ITEM 622 - PORTABLE BARRIER PLACEMENT (I-76 / I-77)

GENERAL NOTES - 4 OF 4

BRIDGE NO. SUM-76-1085
GRANT STREET OVER I-76

SUM-76-10.00
PID No. 77269

DETAIL FOR ITEM 611 - INLET MISC.: REMOVE, PROTECT AND RECONSTRUCT BARRIER MEDIAN INLET (I-76 / I-77)

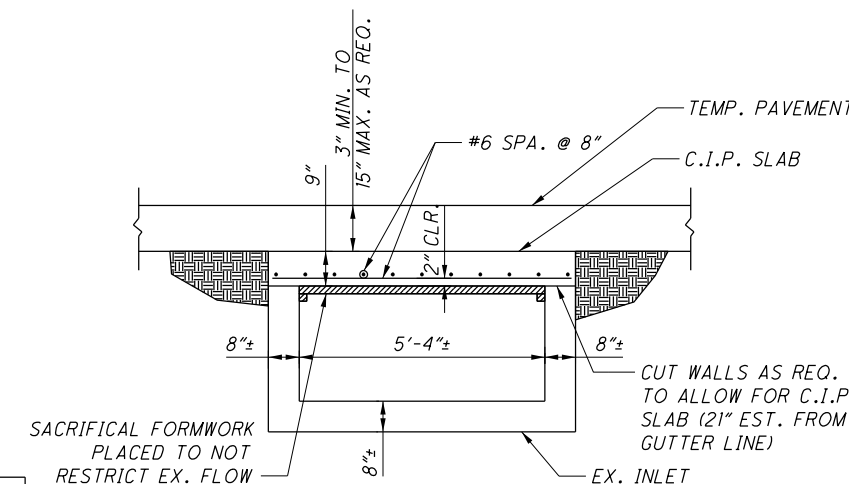
CONTRACTOR SHALL SAWCUT THE EXISTING BARRIER MEDIAN INLET TO A DEPTH OF 21" BELOW PROPOSED GUTTER AND PER REQUIREMENTS OF ODOT CMS 202. THE CONTRACTOR SHALL PROTECT THE EXISTING PIPE INVERT WITH A CONCRETE SLAB AND BACKFILL WITH PROPOSED SHOULDER PAVEMENT SECTION FOR THE DURATION OF THE NEED FOR THE CROSSOVER THROUGH THE MEDIAN. THE SLAB SHALL BE AS PER DETAIL SHOWN. CONCRETE SHALL BE CMS ITEM 511, CLASS OC1 MISC. WITH 4 KSI DESIGN STRENGTH. REINFORCING SHALL BE PER CMS ITEM 509 NO SEPARATE PAYMENT WILL BE MADE FOR TIME, CONCRETE AND REBAR AND OTHER MISCELLANEOUS ITEMS REQUIRED TO COMPLETE THE WORK AS IT IS INCIDENTAL OT THIS ITEM. THE EXISTING INVERT AND ONE SEGMENT OF EXISTING PIPE SHALL BE REMOVED AND REPLACED PER SCD I-2.4. WHEN THE TIME COMES TO REPLACE THE MEDIAN BARRIER WITH NEW BARRIER THE EXISTING MEDIAN INLET MUST BE REMOVED AND THE NEW MEDIAN INLET RECONSTRUCTED IN IT'S ORIGINAL LOCATION AS APPROVED BY THE ENGINEER. ALL MATERIALS, LABOR, AND EQUIPMENT REQUIRED FOR THE COMPLETE INSTALLATION SHALL BE INCLUDED IN THE UNIT PRICE BID PER EACH OF ITEM 611 INLET MISC.: REMOVE, PROTECT AND RECONSTRUCT BARRIER MEDIAN INLET.

PLAN

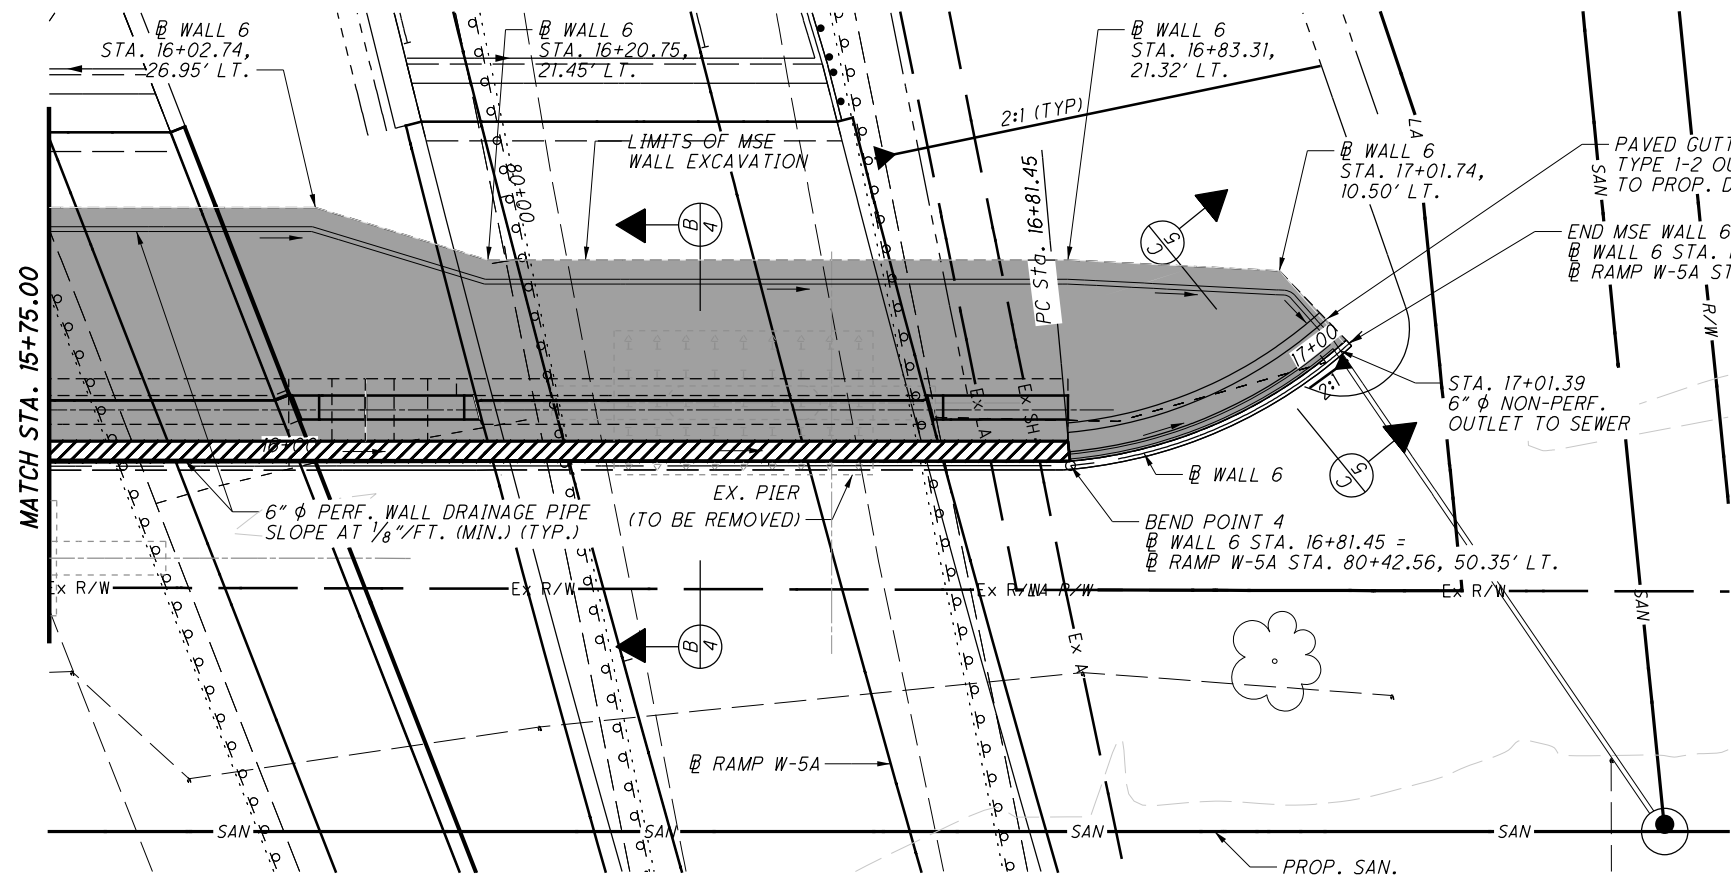
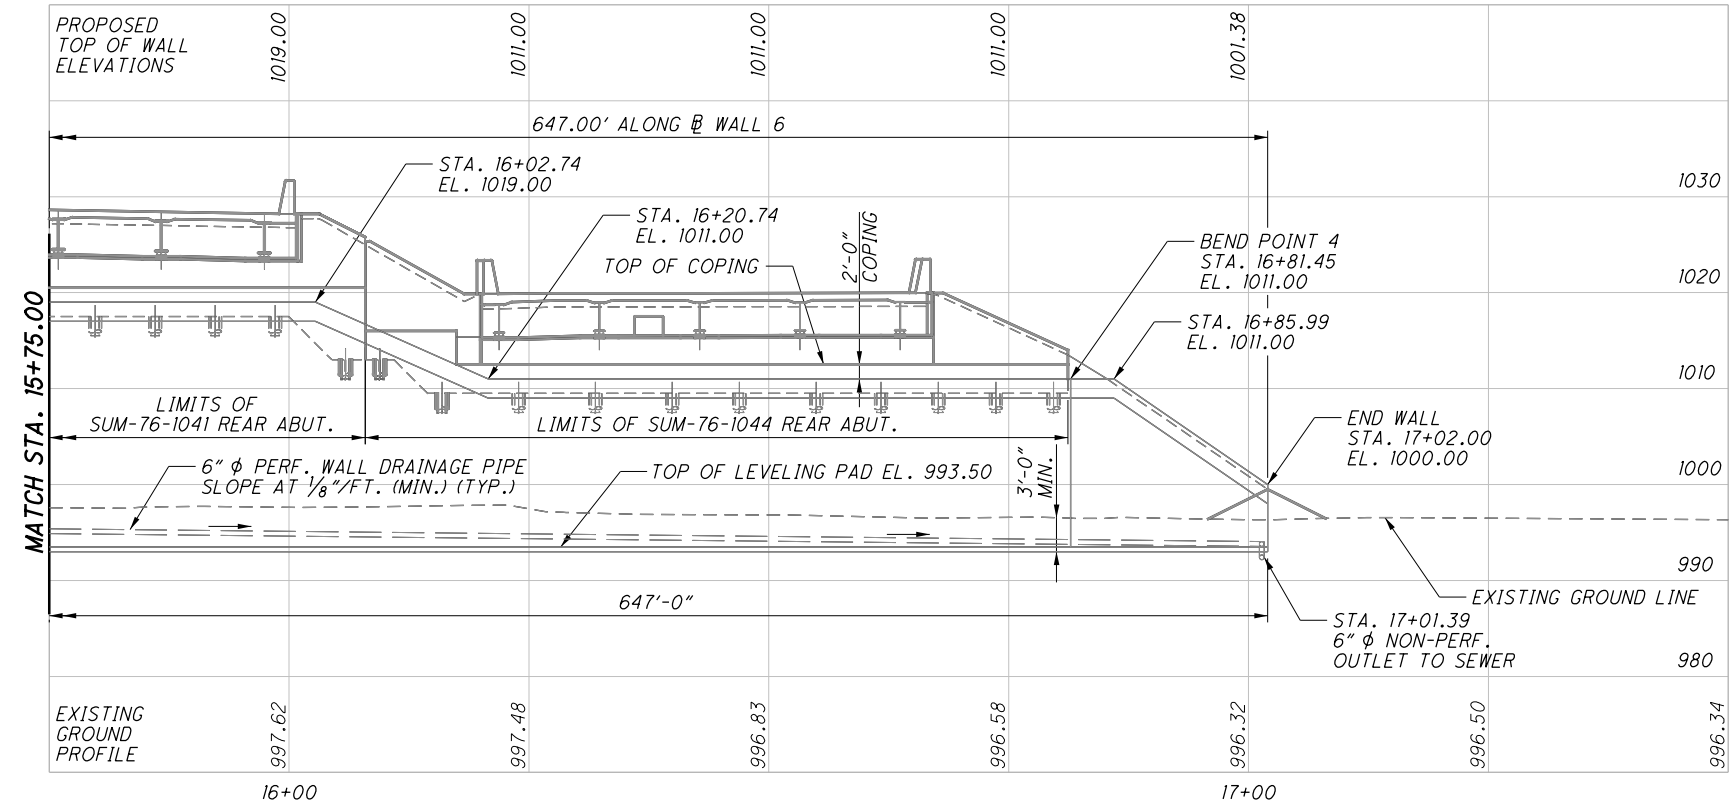
REV. BY	DATE	DESCRIPTION
KMK	4/18/16	ADDED EXCAVATION TO NOTE 7

7. COST OF **(EXCAVATION)** FURNISHING AND INSTALLING **IN PLACE**, THE SUBBASE FILTER, SHALL BE INCLUDED IN ITEM 840, FOUNDATION PREPARATION, AS PER PLAN.
